Field Exam Summary A25-12306 November 15, 2003

General Comments - All Maurice Robison Claims

General Comments - A25-12306

A25-12306 Reservoir Capacity 11/15/03

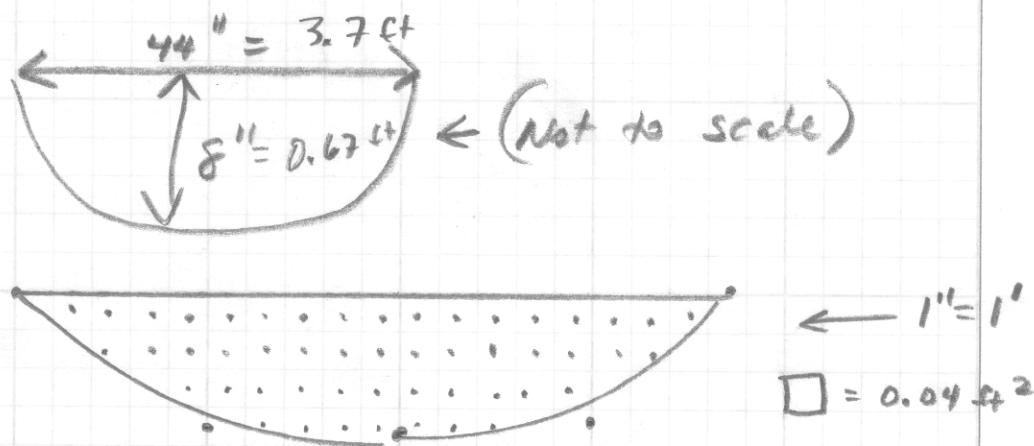
Using a dot grid on the USGS topo map
I count 16 dots $\times$ 0.92 acres $\approx$ 14.7 acres.

It looked like the effective ^{recently used} usable depth of the reservoir is about 4' though it has been dry the last few years. Neglecting the slope of the edges of the wedge of storage water (See photo A25-12306-3.jpg)

the storage volume @ 4' is $4' \times 14.7 \text{ acres} = 59 \text{ acre feet}$.
The neglecting of the wedge is partial accommodation of a potentially greater depth.

As an alternate calculation, the total volume can be seen as an inverted pyramid with a 14.7 acre base and an elevation of ten feet. The claim states "30' High" dam but the USGS map shows reservoir elevation at 6290 and the 6280 foot contour does not reach the foot of the dam. Pyramid volume = $\frac{1}{3}(\text{base})(\text{height})$
 $= (\frac{1}{3})(14.7 \text{ acres})(10 \text{ feet}) = 49 \text{ acre feet}$.

Sketch to accompany
Field Notes 11/6/03
Dac

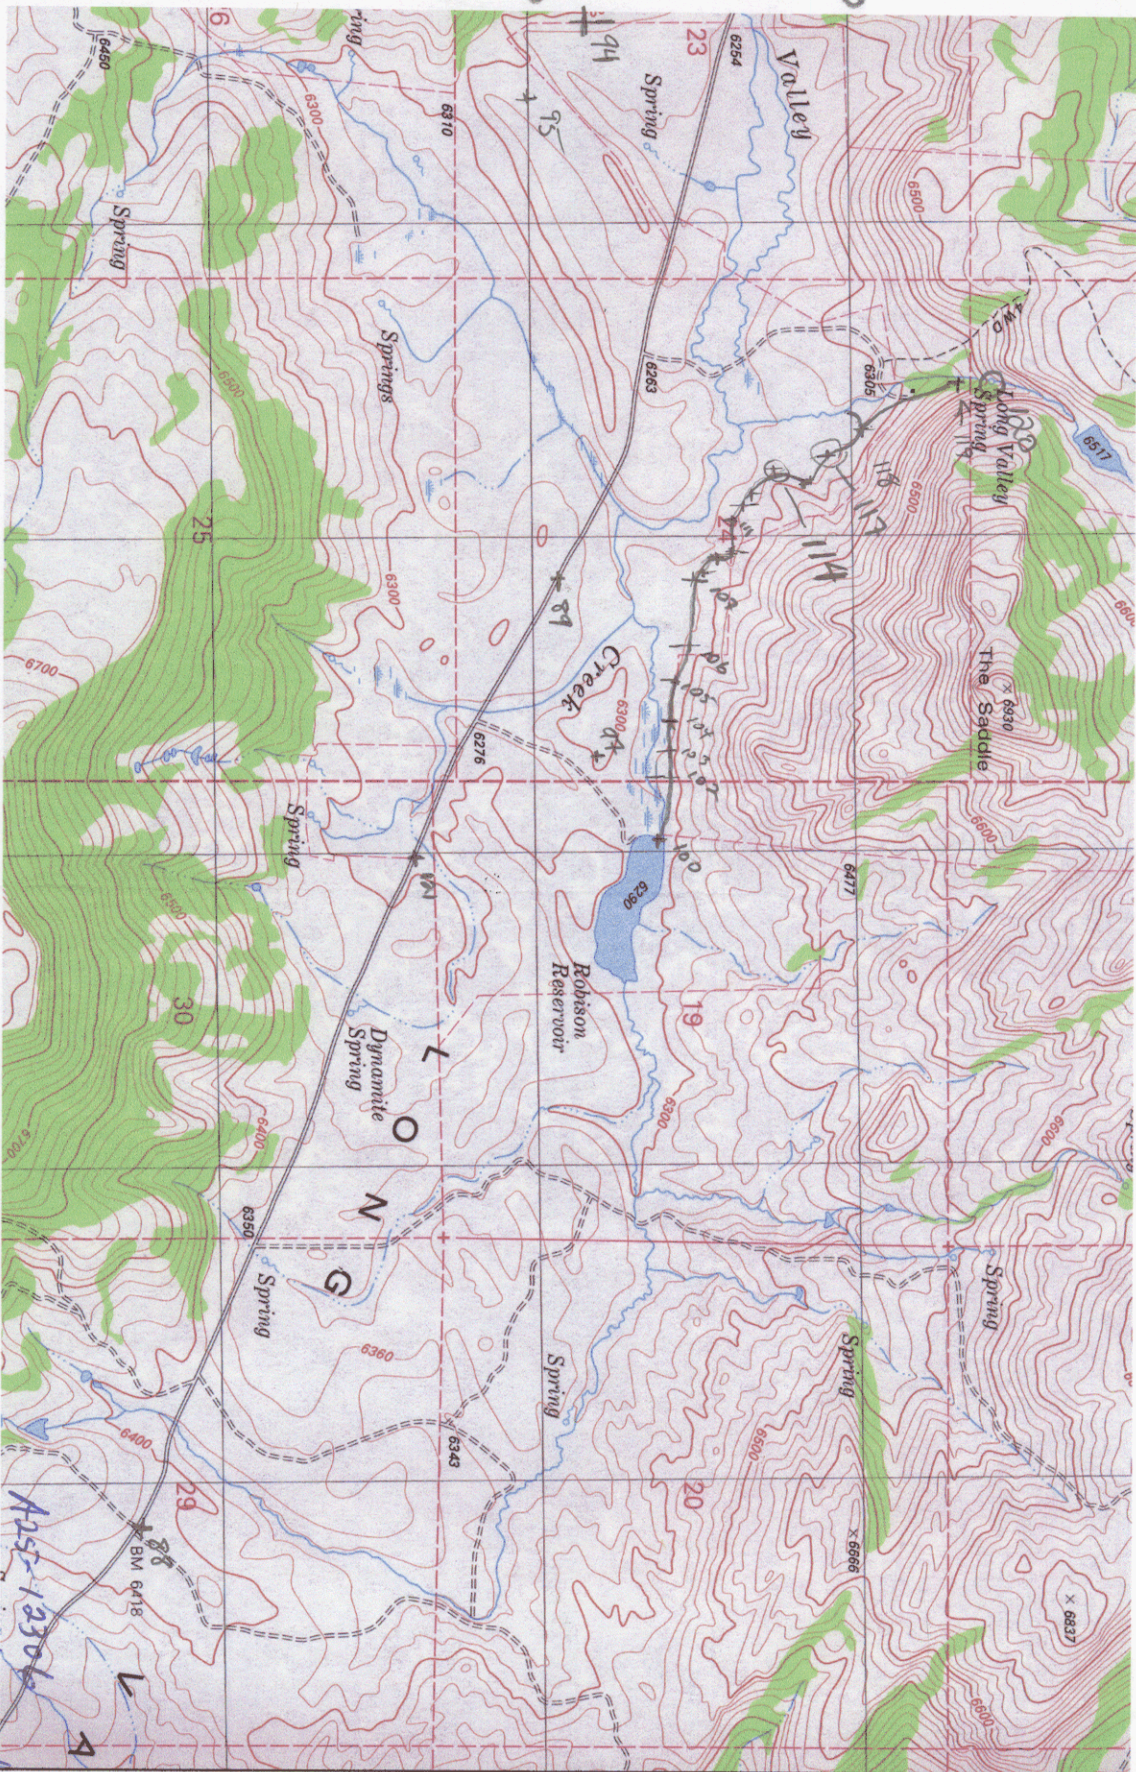
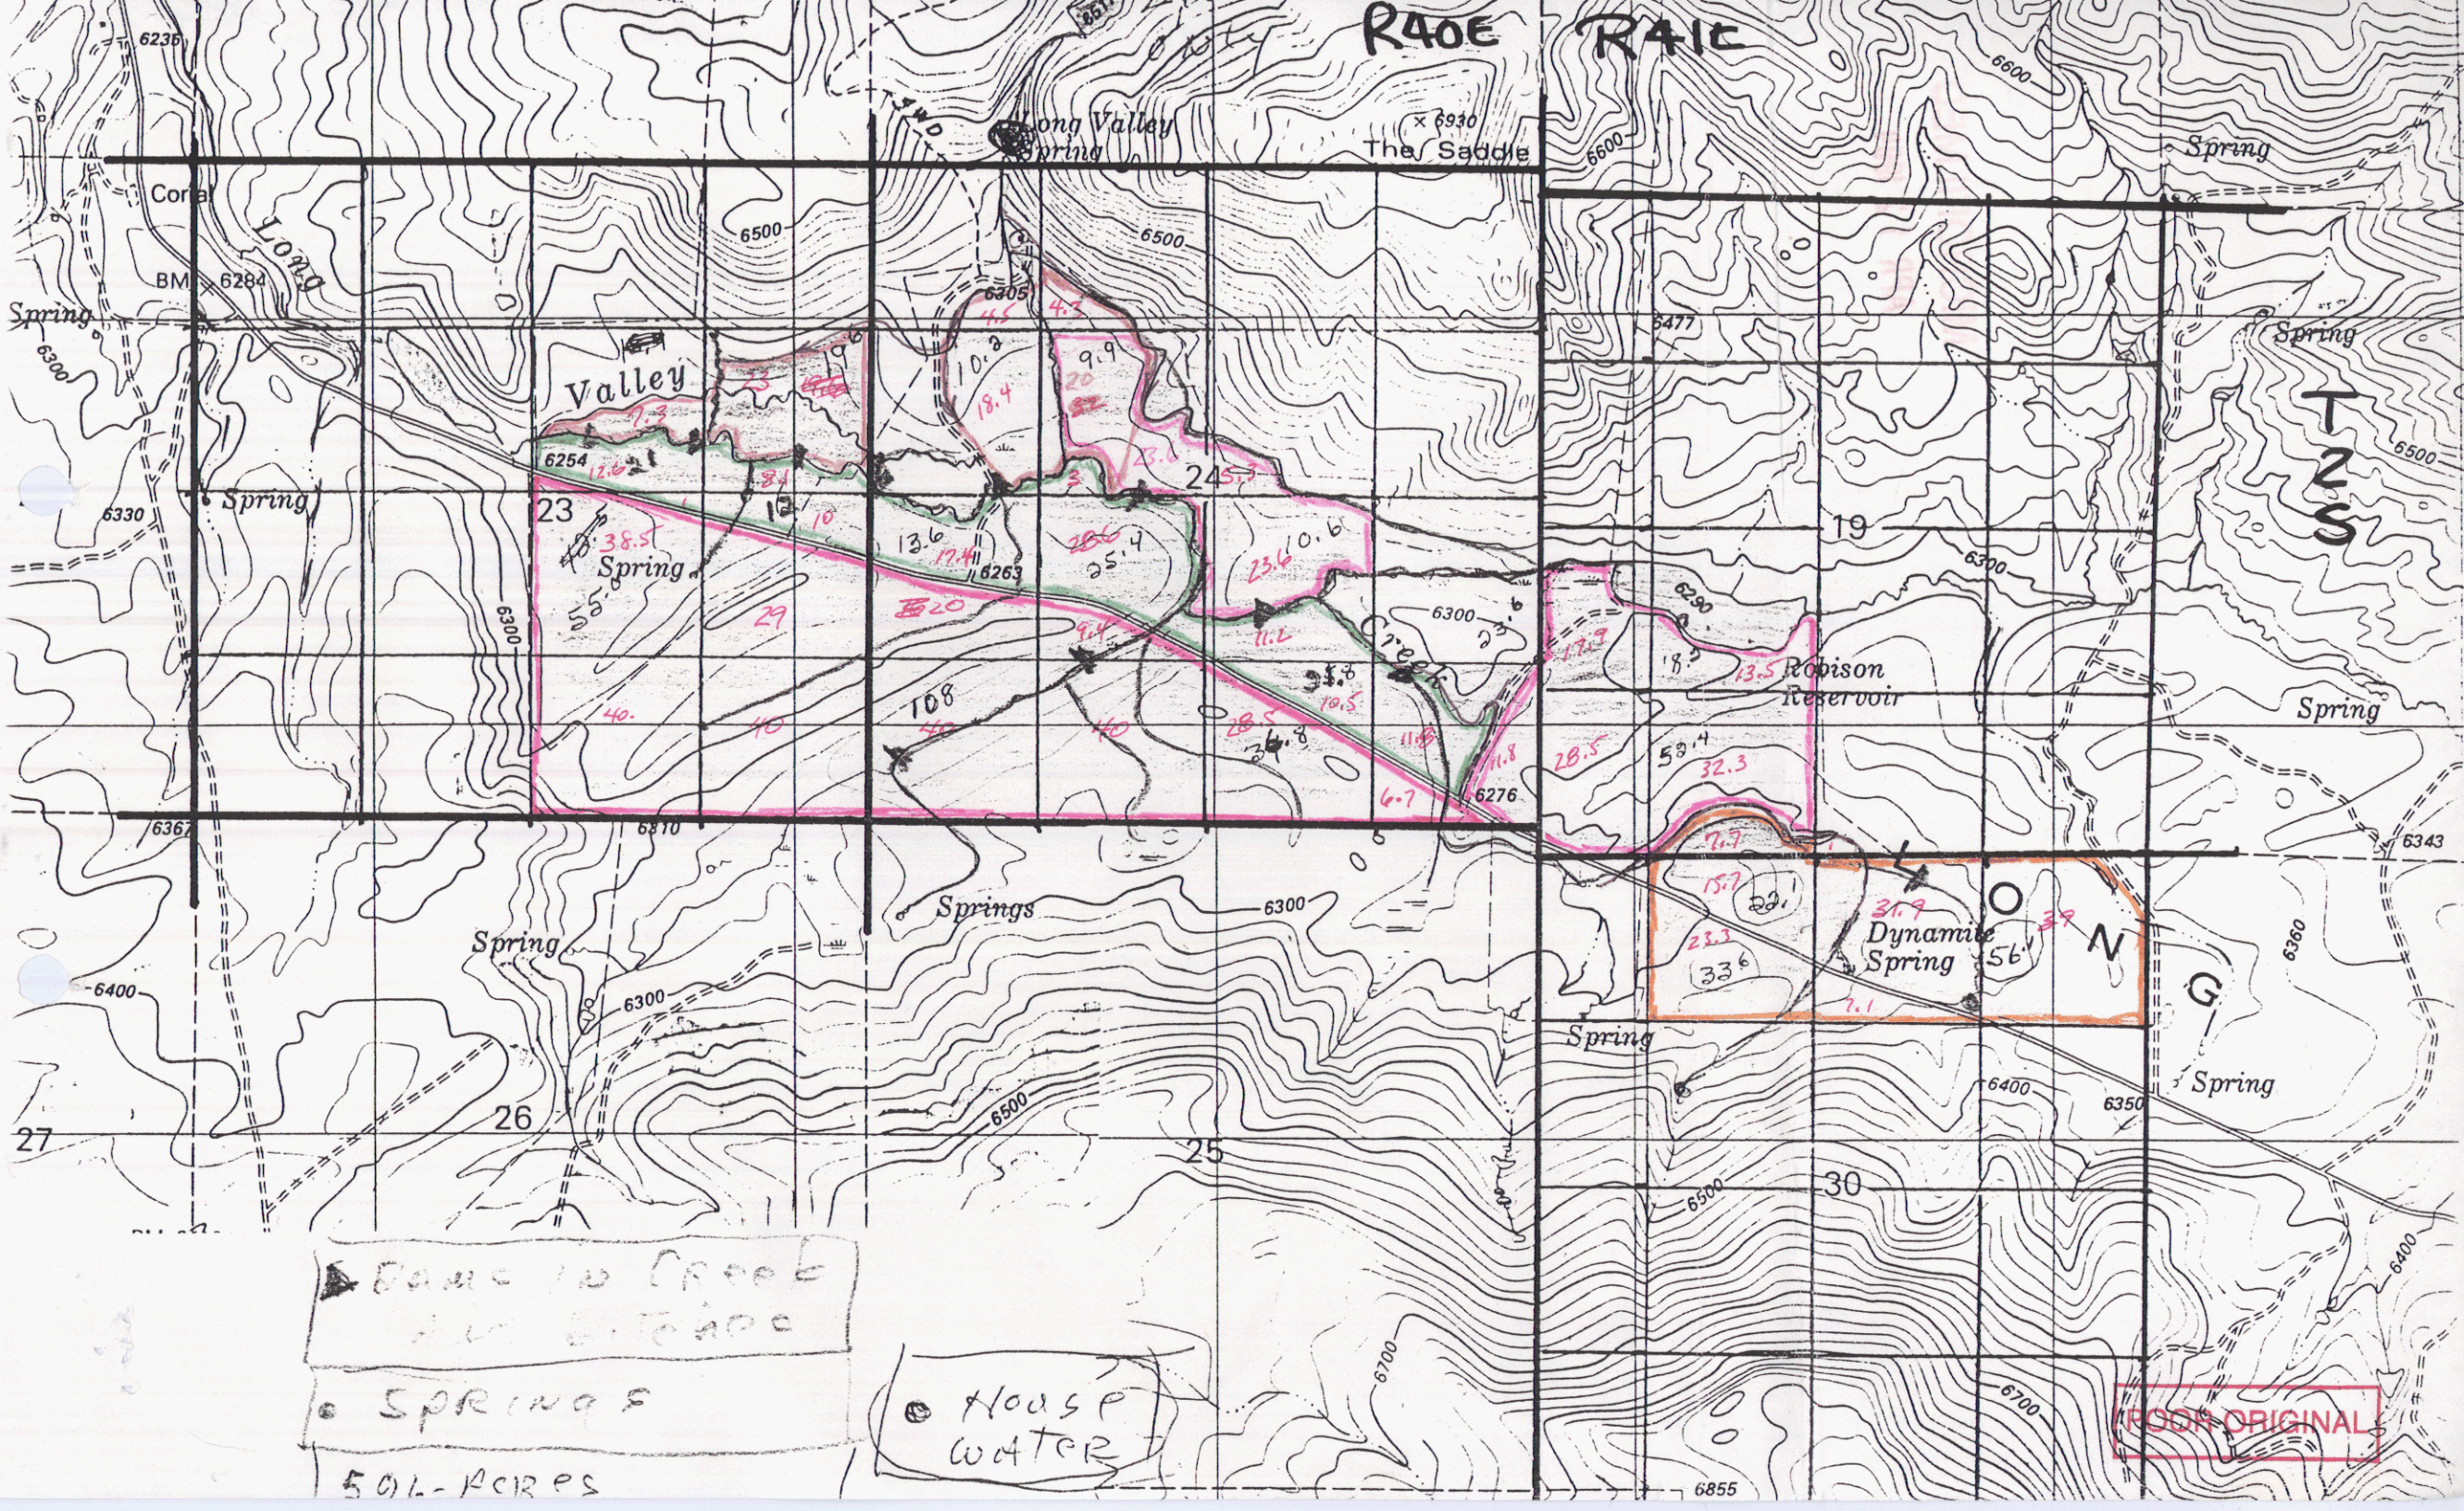
The POU sketch in the claim appears to be about right. I tried to mark the layout but a better representation is the sketch I made on a copy from the USGS map. The uphill (north) edge of the POU is from a GPS traverse and the downhill (south) edge is from the creek on the USGS map. Dot count indicates about 53 acres which corresponds to the claimed acreage.

Tail water from A25-13582 will run down onto this POU and it may be reasonable to recommend overlapping places of use, as I have sketched (see A25-13582 paper file).
